**CITY OF TWIN OAKS  
PLANNING AND ZONING COMMISSION MEETING  
VIRTUAL MEETING  
WEDNESDAY, JANUARY 27, 2021 6:30 P.M.**

Site Development Plan for  
**ALDI, INC.**  
1100 MERAMEC STATION ROAD  
TWIN OAKS, MISSOURI 63021

I obtained from you on December 2, 2020, the Aldi Plan Sheets (4 pages) for the 1100 Meramec Station Road proposed development in commercial district "C". The information was reviewed to evaluate compliance with the Code of Ordinance for Twin Oaks.

**SITE DEVELOPMENT PLAN**

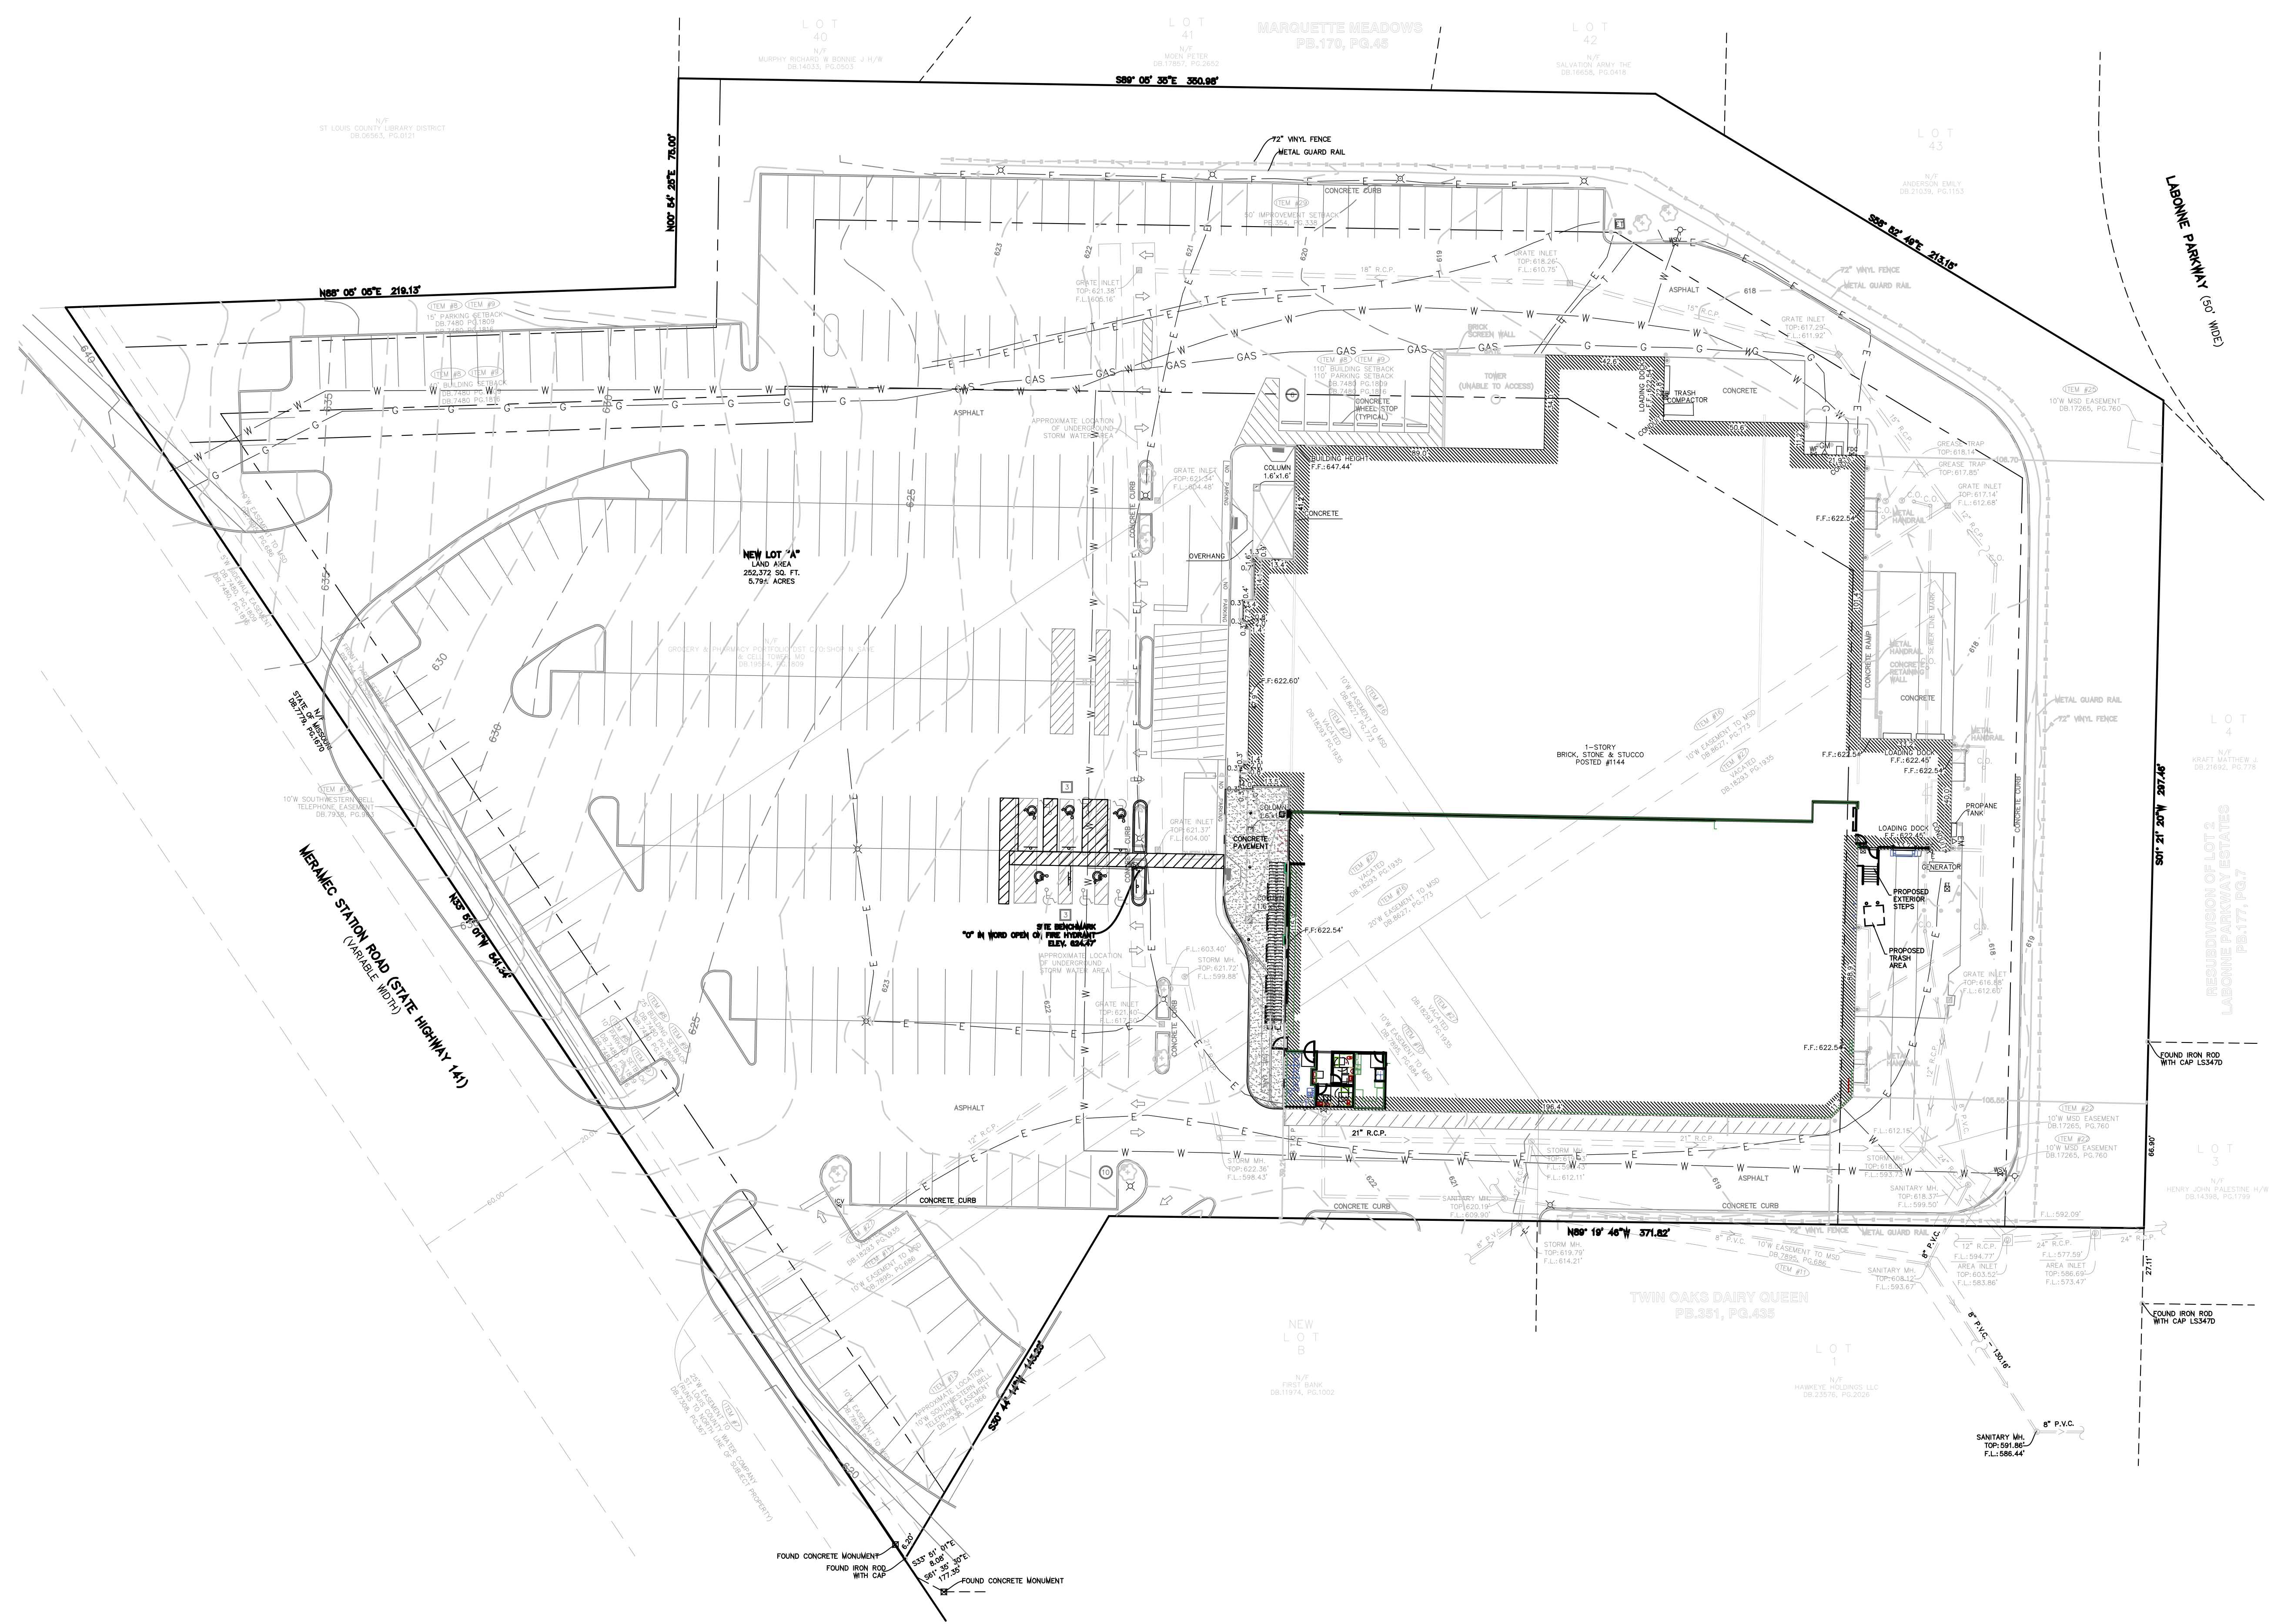
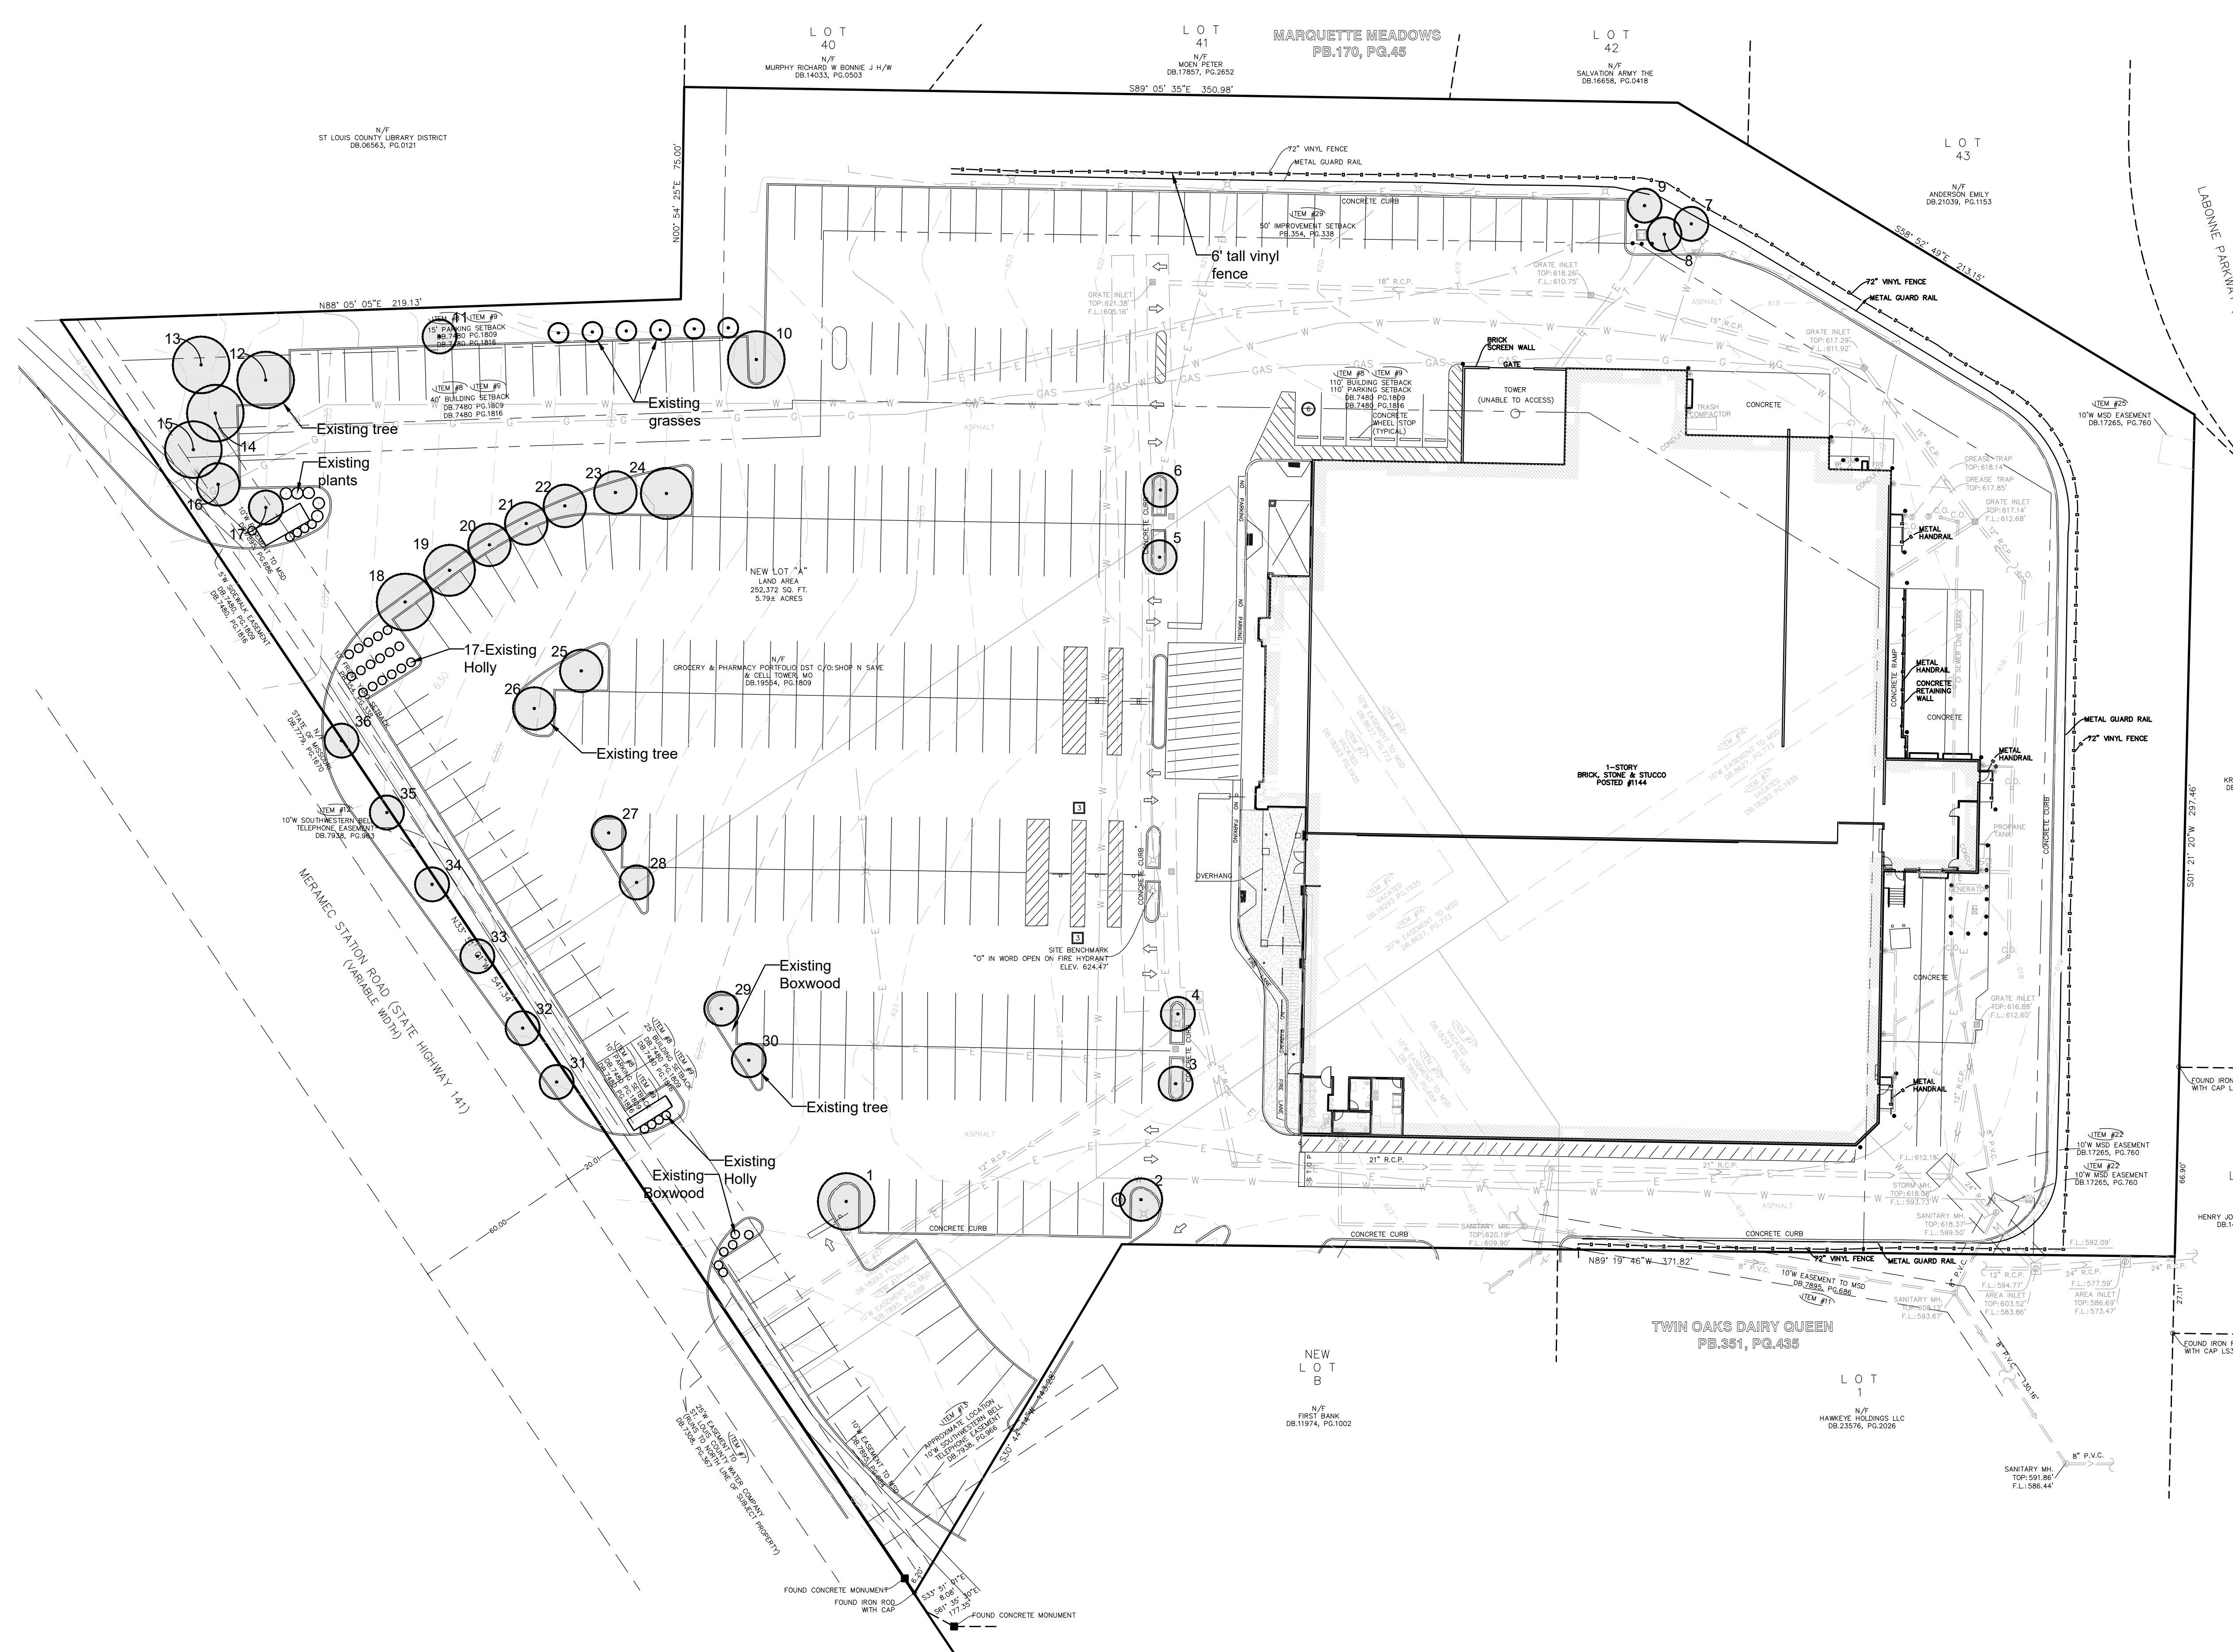
**Paragraph 3 comment 1:** Please dimension the proposed parking spaces; current plans do not dimension the proposed parking spaces. Please ensure the proposed parking spaces are a minimum of 180 square feet, per Section 400.080.

**Paragraph 3 comment 7:** The proposed ADA parking area does not display grading. Grading is necessary to determine whether the space is compliant with ADA requirements. Please provide a grading plan to ensure ADA parking is compliant with the ADA requirements per Appendix A C.2.

**Response:** The Civil engineer CEDC will respond.

**Response:** The Civil engineer CEDC will respond.

**2<sup>nd</sup> Review: This comment is addressed.**
2. Please provide a plan that displays the proposed rooftop equipment. Ensure proposed rooftop equipment is adequately screened per Section 400.330 A.6.

**2<sup>nd</sup> Review: This comment is addressed. More detailed plans are needed for County Review.**

Concept  
Exterior Elevations  
Drawing Name:

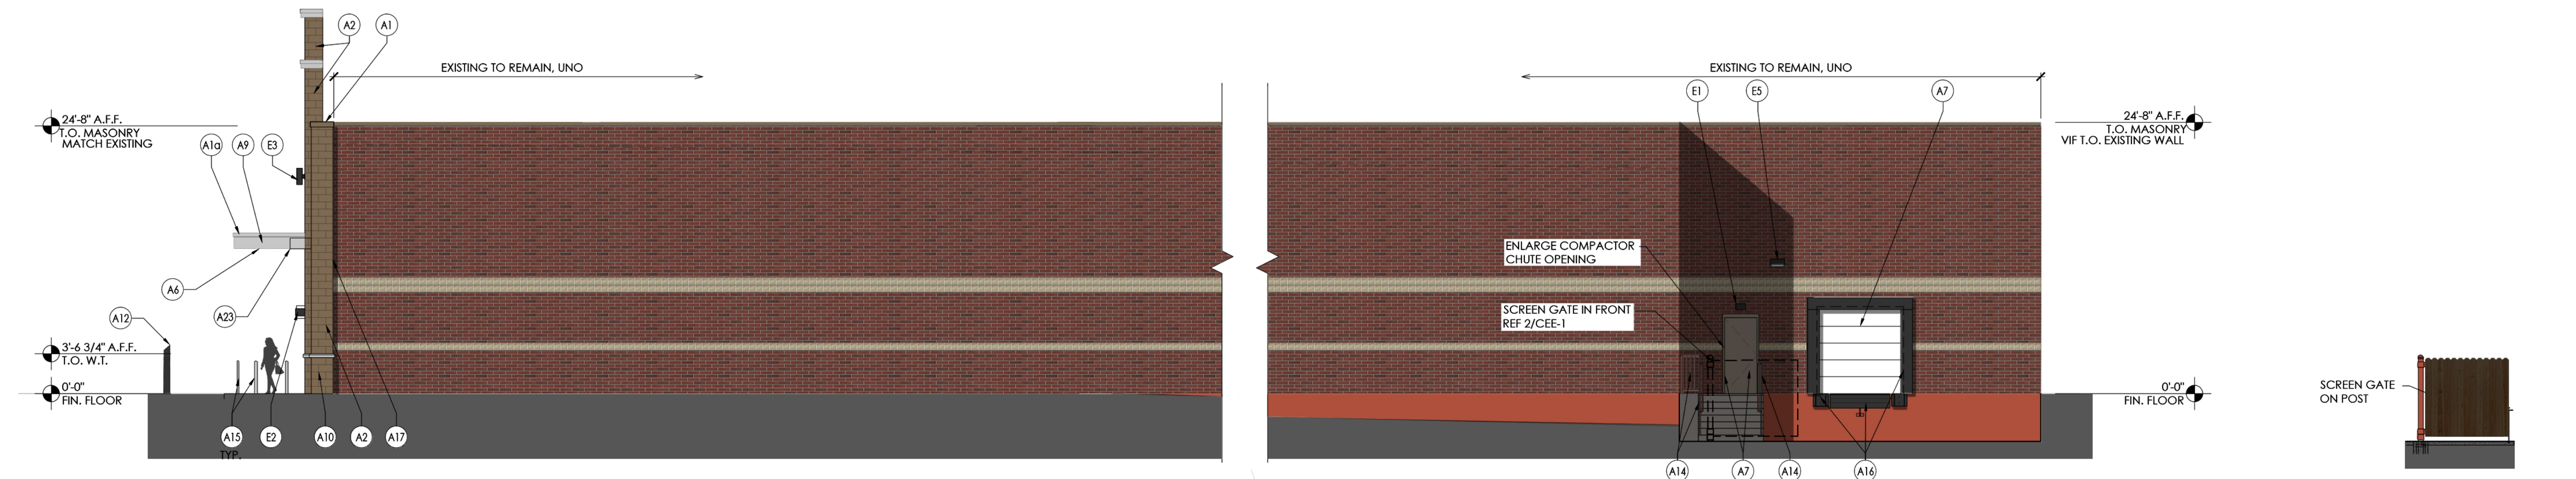
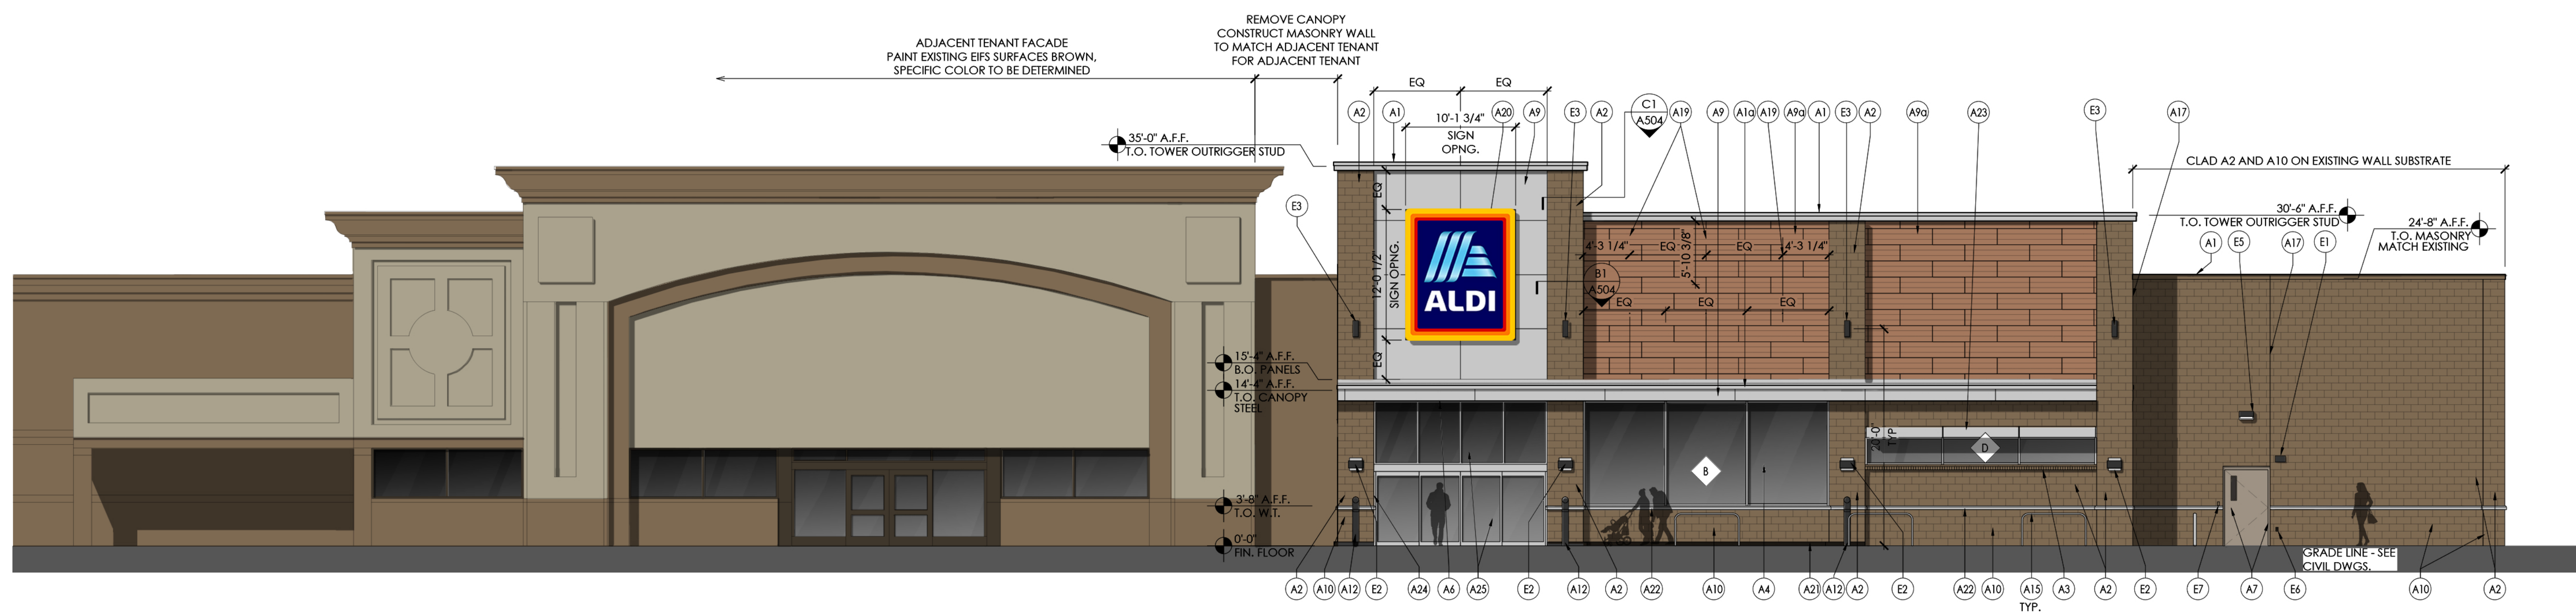
**Paragraph 1 comment 2:** Exterior Finish Schedule A2: Please reevaluate the design to utilize a material chosen from the Allowable material list in Appendix A A.5; “Spec-Brick Concrete Masonry Veneer” is not allowed, because concrete block or masonry unit is not allowed per Appendix A A.6.

**Paragraph 1 comment 3:** Exterior Finish Schedule A3: Please reevaluate the design to utilize a material chosen from the Allowable material list in Appendix A A.5; “Concrete Masonry 4” H Accent Band” is not allowed, because concrete block or masonry unit is not allowed per Appendix A A.6.

**Paragraph 1 comment 5:** Exterior Finish Schedule A10: Please reevaluate the design to utilize a material chosen from the Allowable material list in Appendix A A.5; “Oldcastle/Echelon Masonry Concrete Masonry Veneer” is not allowed, because concrete block or masonry unit is not allowed per Appendix A A.6.

**Paragraph 1 comment 6:** The current design does not provide screening to the proposed trash container. Please reevaluate the design and screen trash container with evergreen hedges, walls, screens planted with evergreen vines per Appendix A F.4.

**Paragraph 3 comment 4:** Exterior Finish Schedule A6: With provided information, location was not determined. Please note: metal panels are not on the approved materials list per Appendix A A.5.

**Response:** A10 is a type of split-face CMU. While it is composed of concrete, it has aesthetics and texture similar to bricks. Please see **enclosed CEE-1** with keynotes A2 and A10 simplified on the Front Elevation.

**Response:** The view from La Bonne Pkwy on the east is almost completely screened due to the existing retaining wall with fence, as well as a significant drop in grade elevations. The view from the neighboring business on the south is on the same boat, but a screen door is added. Please see **enclosed CFP-1 and CEE-1**.

**Response:** A6 is a soffit of the canopy, which is not readily visible unless one is under it. This is not a metal siding. Please see **enclosed CEE-1** with the keynote A6 added.

**2<sup>nd</sup> Review: This comment is addressed. A screen gate is proposed, as displayed on CEE-1.**
